**Thunder Spirit Wind Energy Project
Thunder Spirit Wind, LLC
Adams County, North Dakota**

**AMENDMENT to the North Dakota Public Service Commission
for a Certificate of Site Compatibility (Updated September 9, 2013)**

Case No.: PU-11-601

REVISED FIGURES (FIGURE NUMBERS WERE NOT CHANGED)

Revised Figure 3

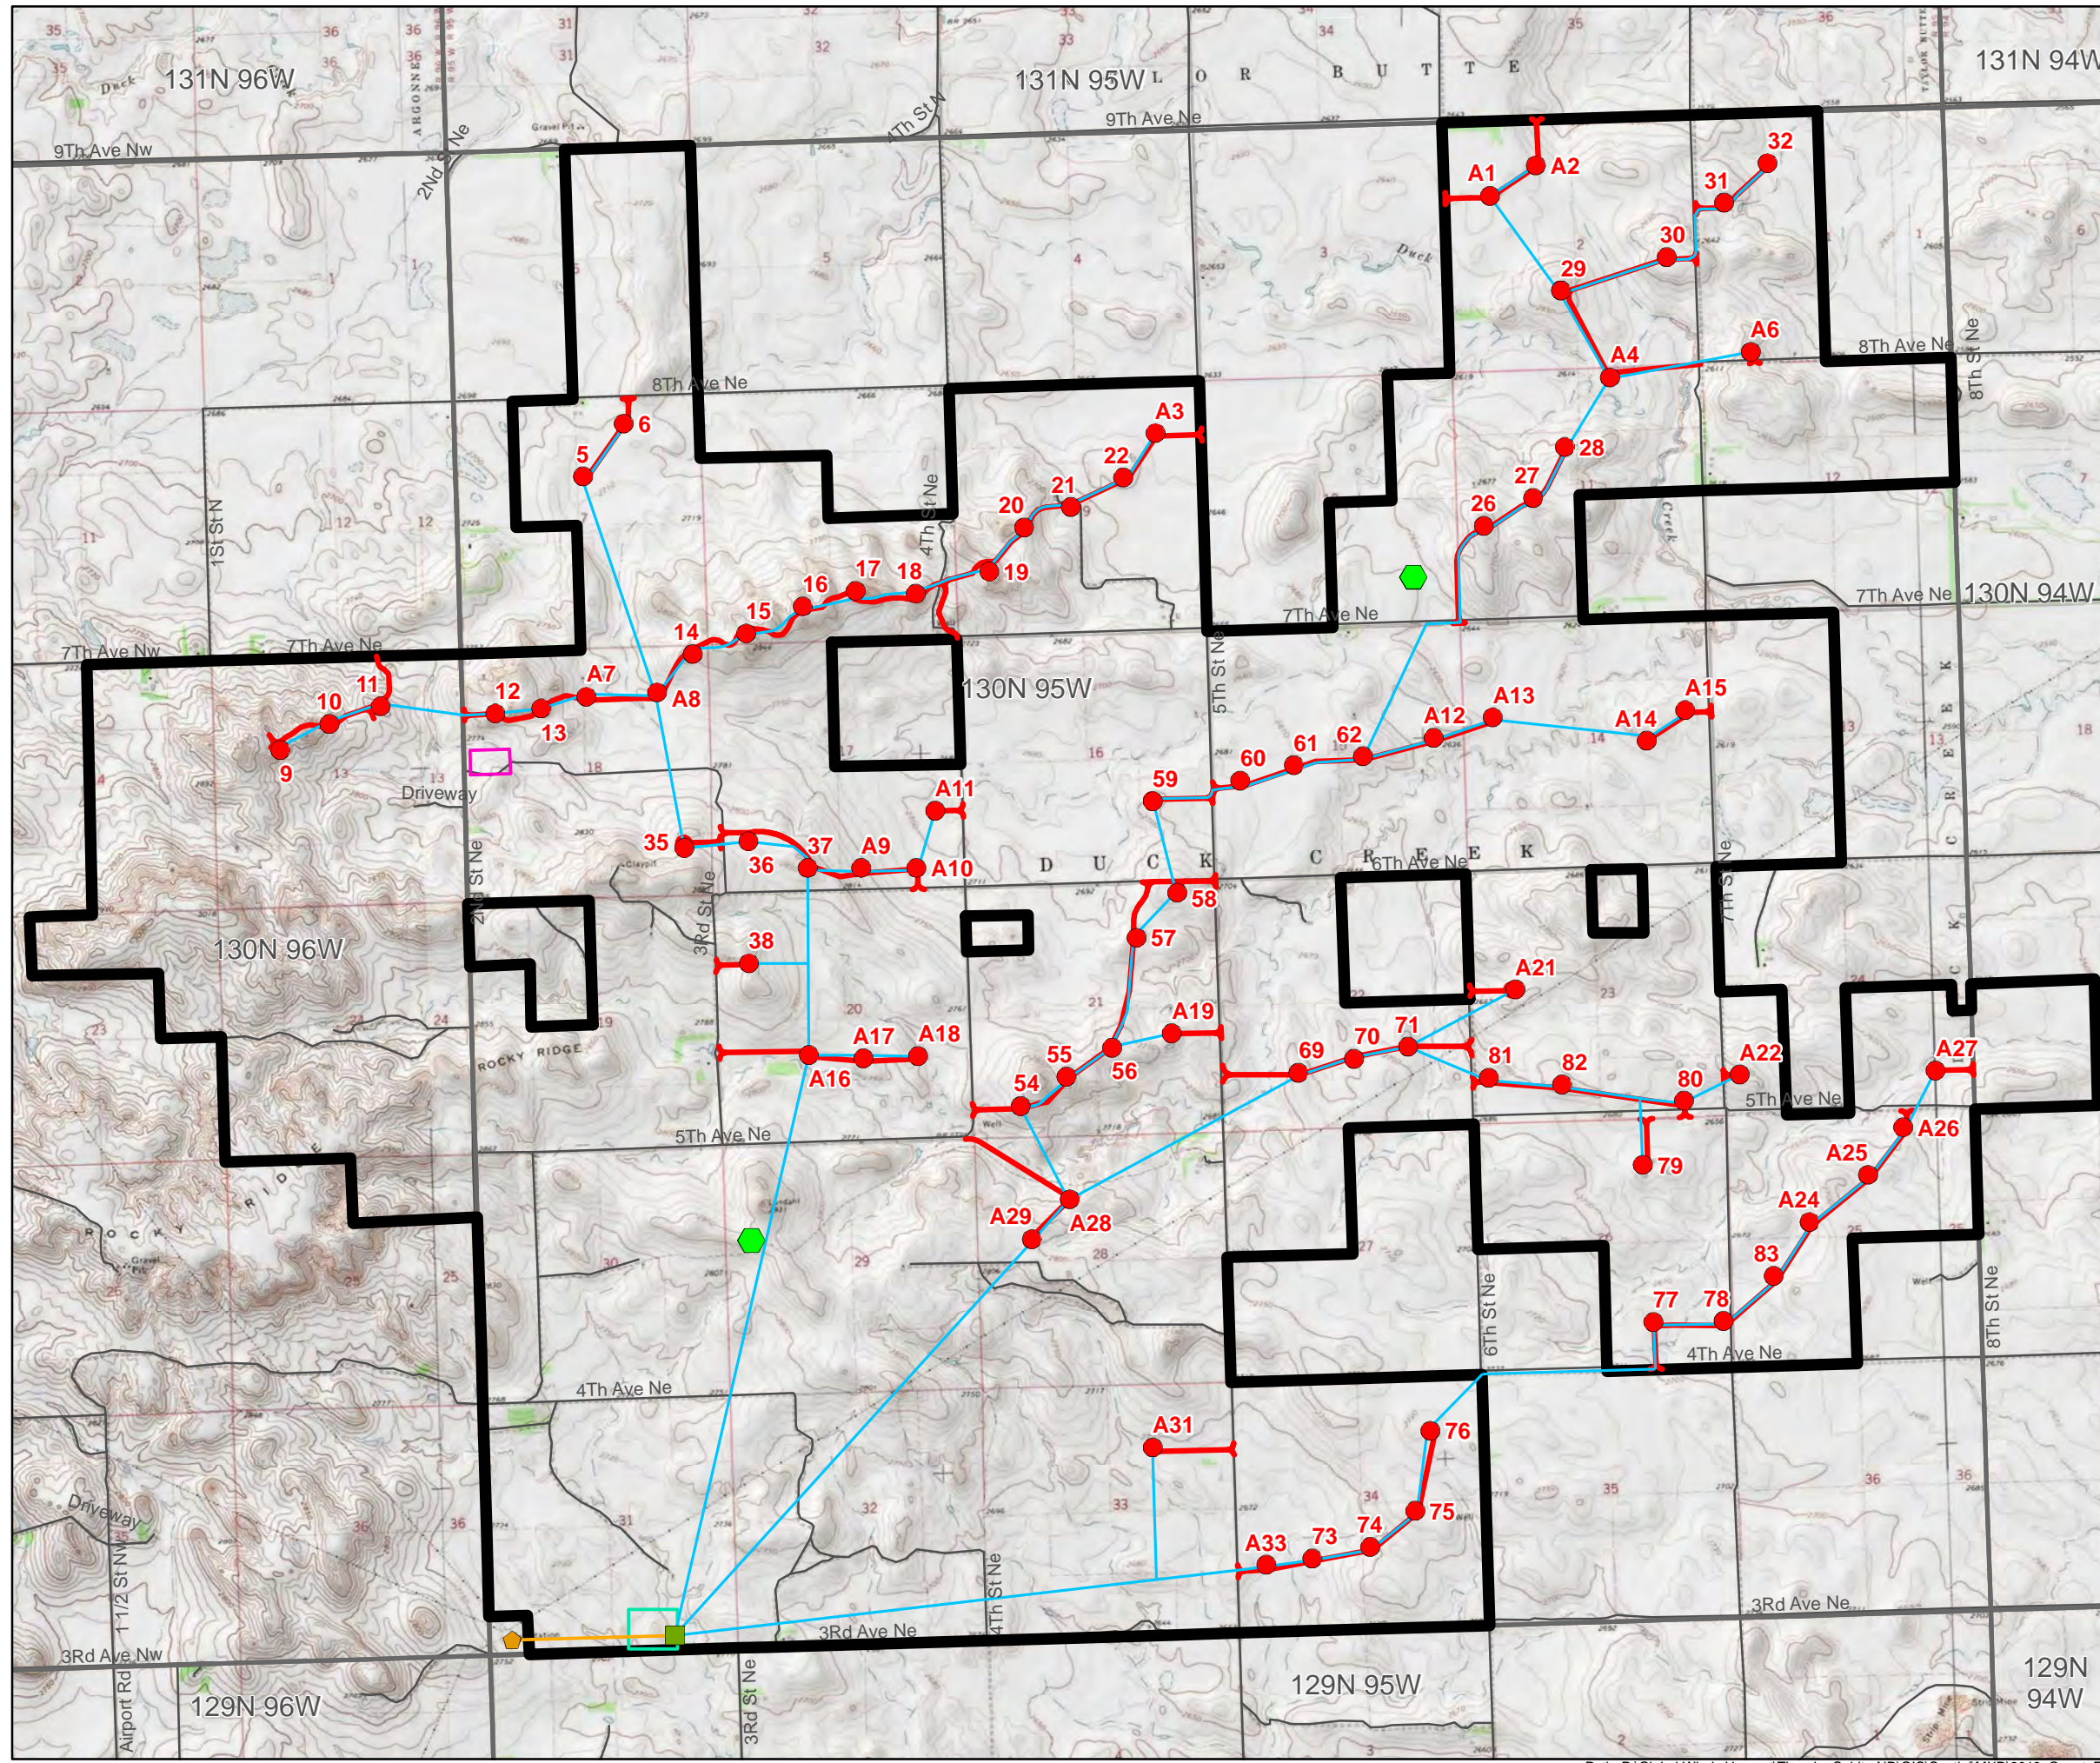
Figure 3	Project Area (Topographical)
Figure 5	Exclusion and Avoidance Areas
Figure 17	Residential Receptor Distances to Closest Wind Turbine
Figure 18	Project Layout with Adams County Zoning Setbacks
Figure A (new)	Turbine Adjustments

Layout Comparison
4/26/13 vs 8/15/13

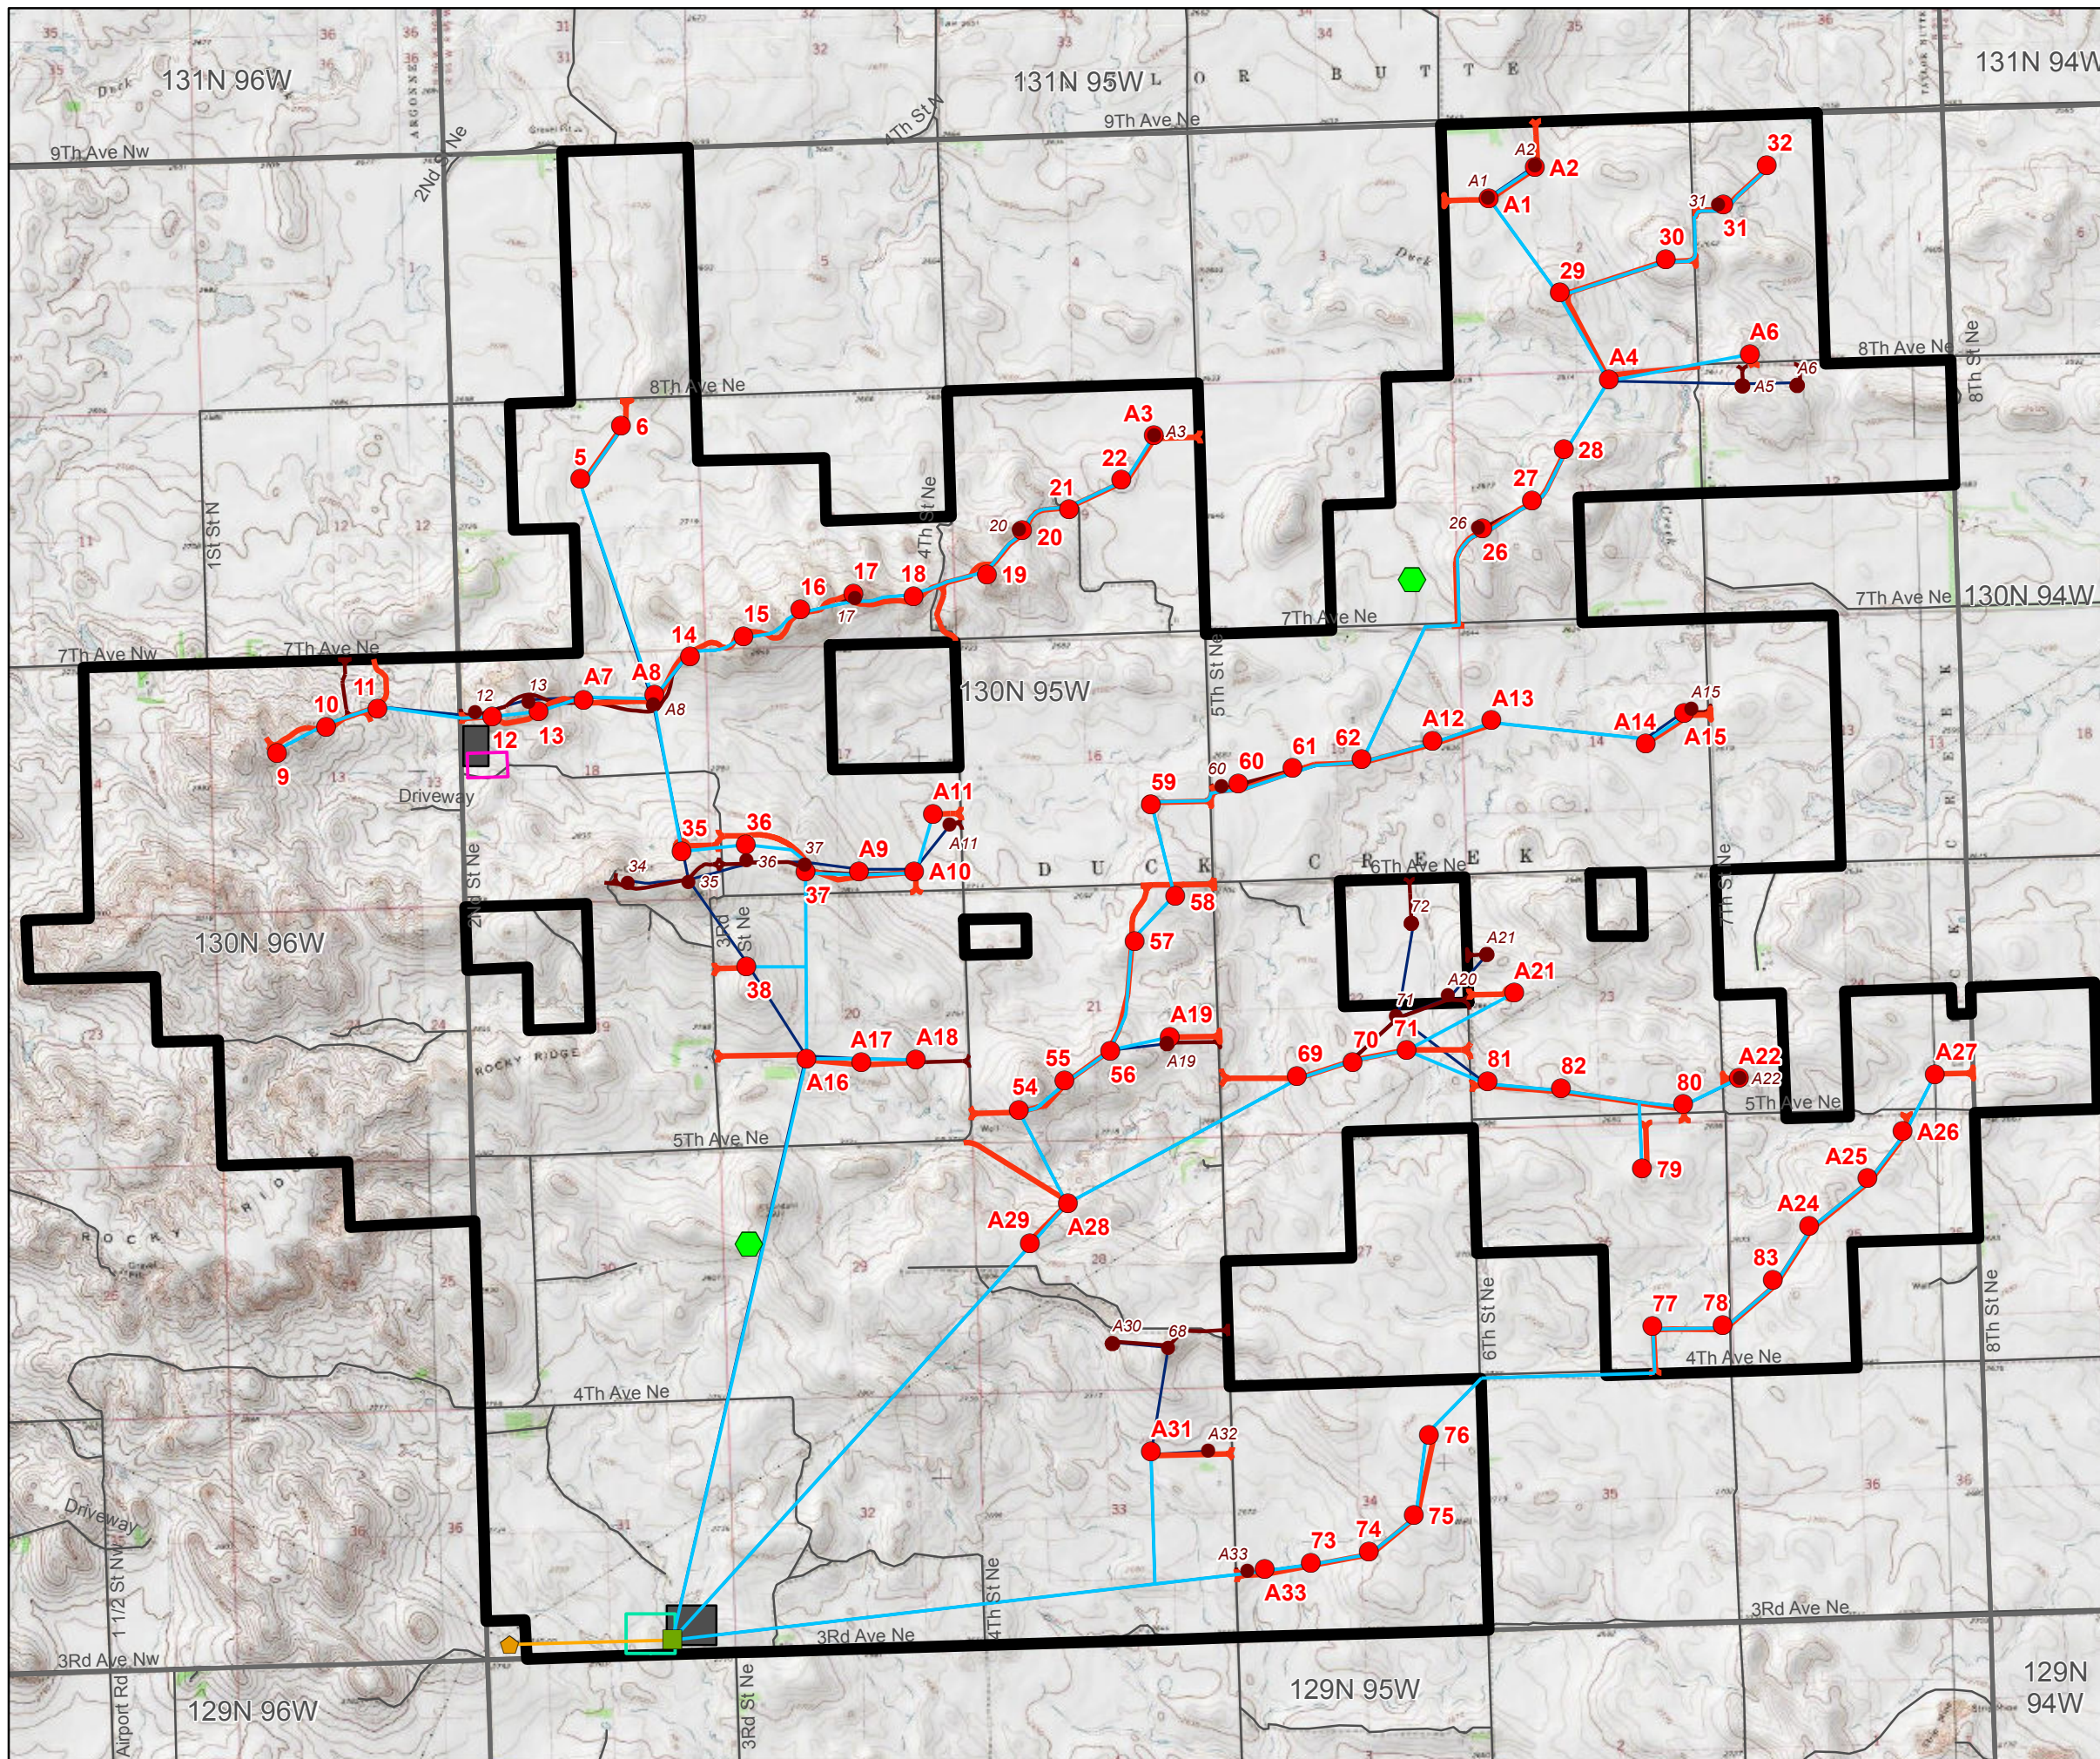
The table below lists the turbines that were moved and the old and new distance to the nearest receptor. Figure A shows the turbine relocations and differentiates between the locations submitted as part of the Application and the revised locations. Tables summarizing impacts (or lack thereof) relating to the latest round of layout adjustments are also included in this Amendment in the following section.
